**THE
NATIONAL
BOARD**
OF BOILER AND
PRESSURE VESSEL
INSPECTORS

**SUBGROUP
ON REPAIRS and ALTERATIONS
SPECIFIC**

MINUTES

*Meeting of January 15, 2013
Mobile, Alabama*

Schematic of Welding Approach – Minor Repair

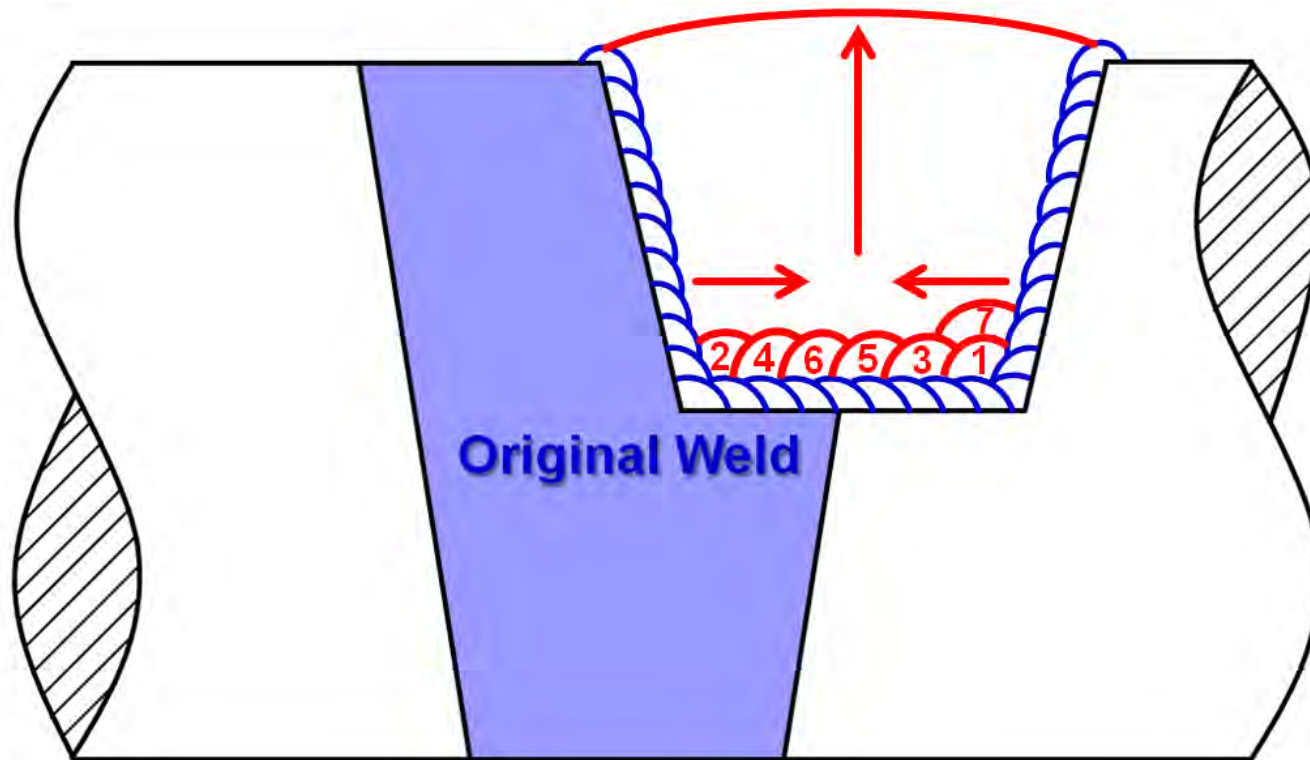
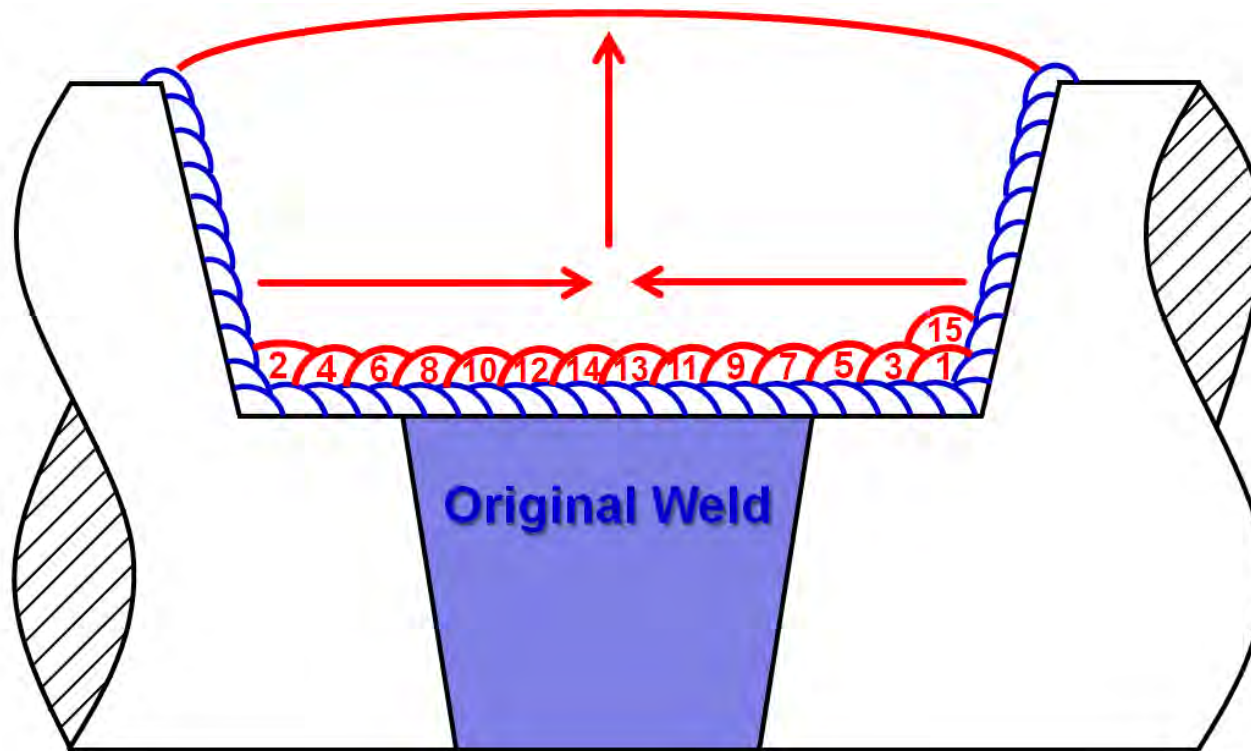
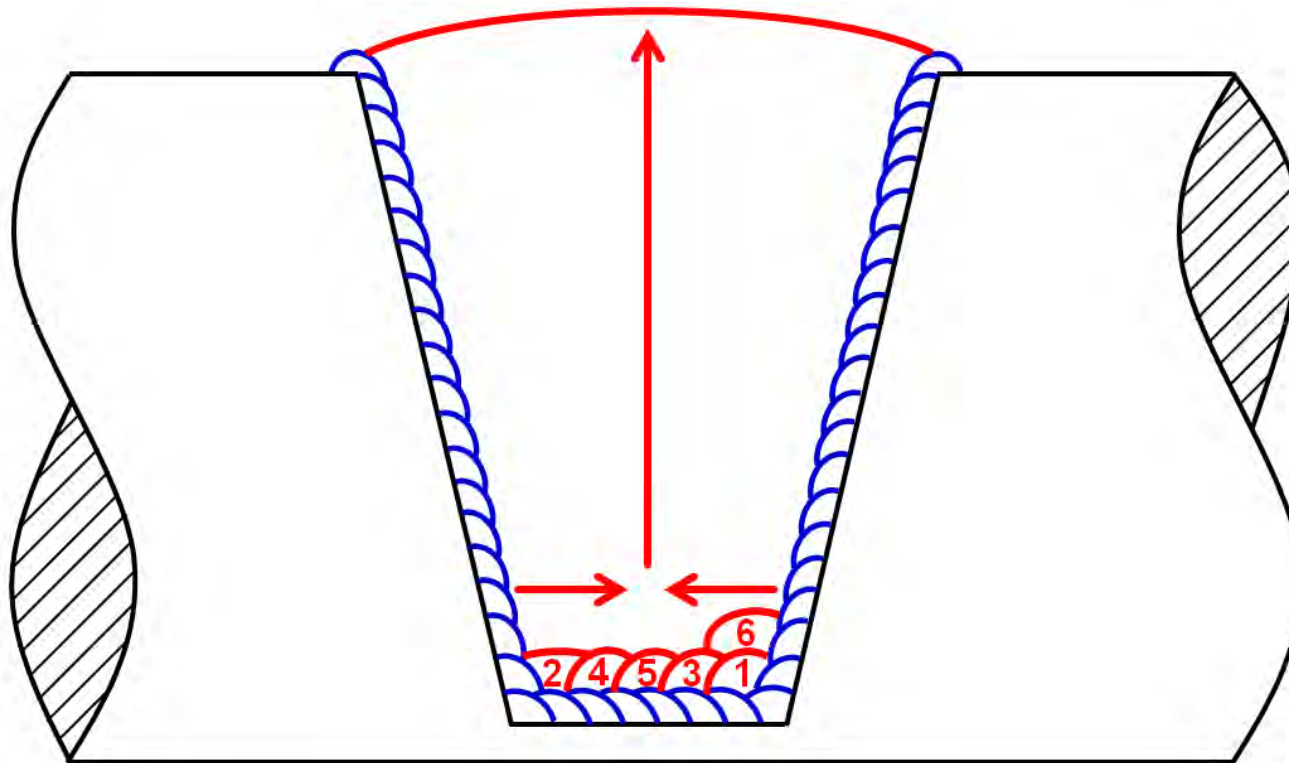
A progress report and presentation on this Action Item was given by G. Galanes. Use of the word "Normal" in the charts was questioned, i.e., does this mean "normalized"? George said he will clarify this.
